Department of Energy

SILO 3 INFORMATION NEEDS

**RESPONSE TO FERNALD CITIZENS TASK FORCE COMMENTS ON THE
DRAFT SILO 3 ALTERNATIVES EVALUATION REPORT
October 17, 1996**

FIGURE 1
ESTIMATED DISPOSAL VOLUME FOR
VITRIFIED SILOS 1, 2, AND 3 BLEND

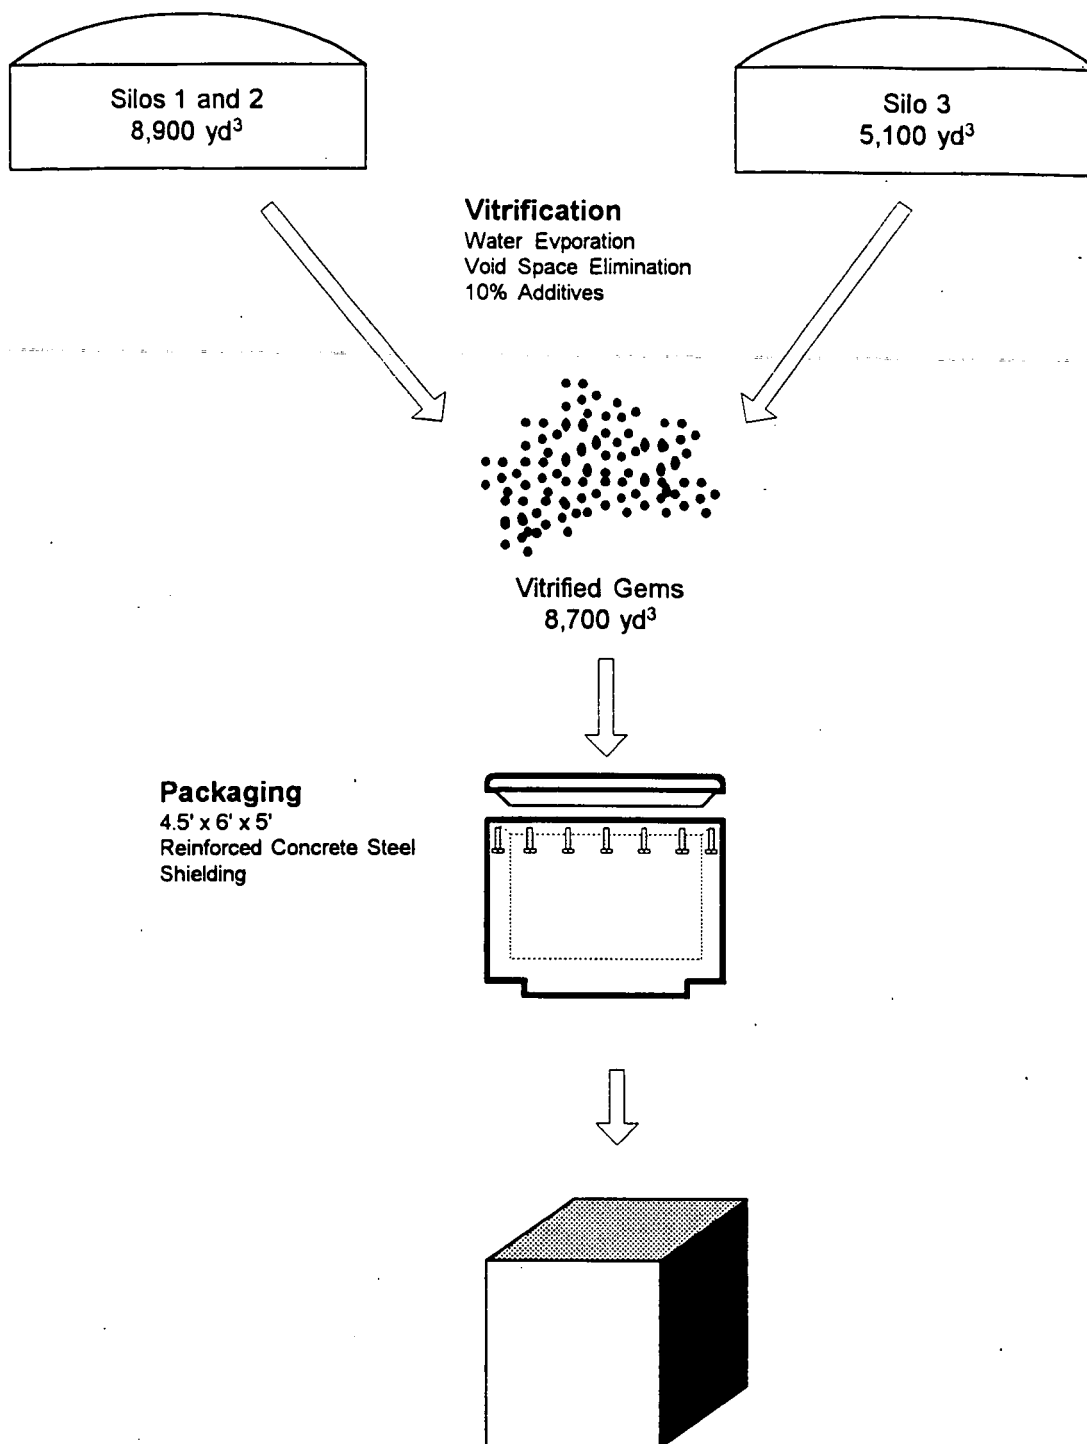
Comment: There is significant concern regarding the increased volume of wastes associated with cementation. We would like a detailed analysis on the volume of waste associated with vitrification versus cementation.

that leave the FEMP. Although vitrification results in a reduction in treated waste volume, this reduction is offset by the increase in disposal volume associated with the concrete container required to keep radiation levels ALARA. Figures 1 and 2, in Attachment 2, present a volume comparison for the vitrified Silos 1, 2, and 3 wastes versus vitrified Silos 1 and 2 wastes and cement stabilized Silo 3 wastes, respectively. These comparisons are based on data presented in Volume 2 of 2 of the Draft Final Evaluation of Silo 3 Wastes Alternatives Report (December 1996).
